**City of Phoenix**  
PLANNING AND DEVELOPMENT DEPARTMENT

**Staff Report: Z-22-24-8  
(40th Street PUD)  
November 8, 2024**

**Proposal:** PUD to allow multifamily residential

**Location:** Southeast corner of 40th Street and McDowell Road

Conceptual Site Plan date stamped October 3, 2024

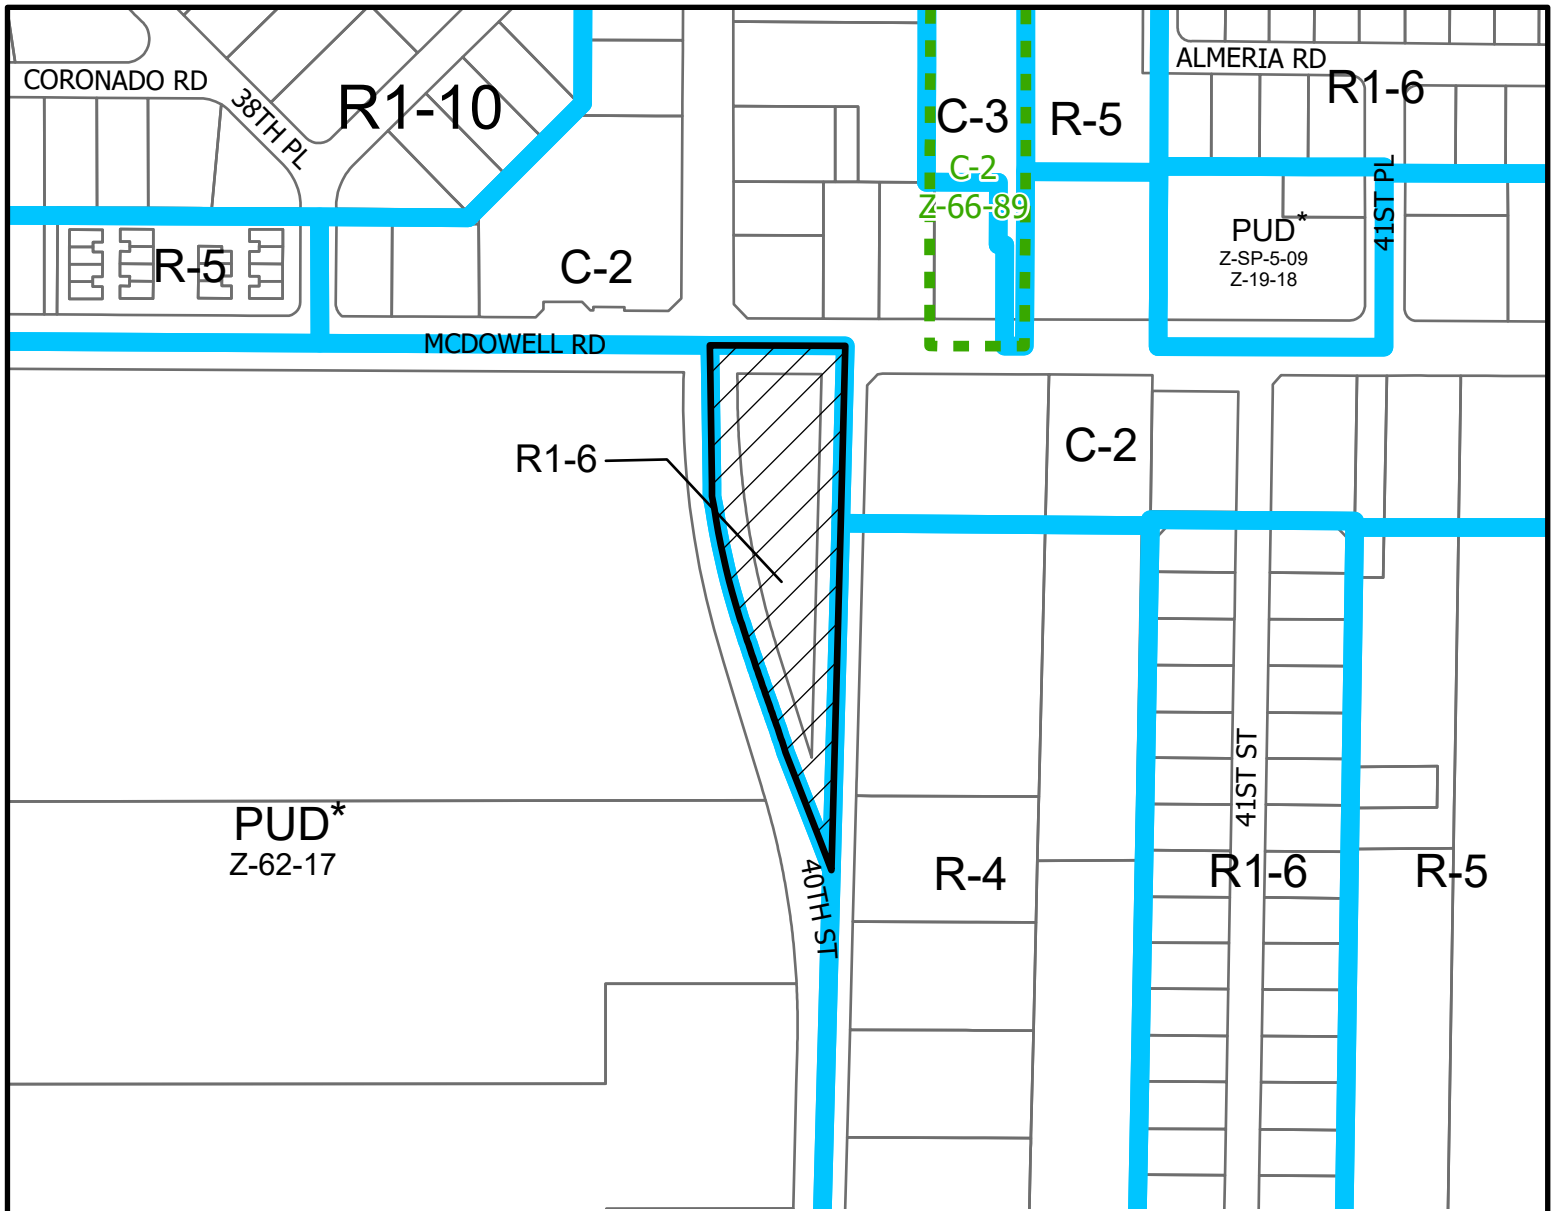
The conceptual site plan, attached as an exhibit, proposes up to 78 residential units in a four-story building that is configured to the unique triangular-shaped site with vehicle access from 40th Street and the 40th Street bypass. This proposal includes five percent open space and first floor parking beneath the residential units. Detached sidewalks will be provided along 40th Street and McDowell Road, and an attached sidewalk will be provided along the 40th Street bypass that will include trees and landscaping to promote pedestrian activation. The proposal will also reconstruct the bus pad on McDowell Road with the addition of landscaping to mitigate heat impacts. The conceptual site plan depicts on-street parking along 40th Street, this parking is for public use and does not count toward the number of required parking spaces. Staff recommends that the on-street parking be deleted. This is addressed in No. Stipulation 1.f.

As i review the site plan I see hidden in design plan that a partial Abandonment of road with on street parking proposed, I think all parking should be on site, Parking on existing street will result in limited access for Fire ,Life and safety along with flow of traffic.

- Pressure regulating sprinklers heads and/or drip irrigation lines shall be utilized in any turf areas to reduce water waste.
  - f. Tab B: Conceptual Site Plan Exhibit: Delete on-street parking. As noted in 1.d. the on-street parking is for public use only and does not count toward the required parking.
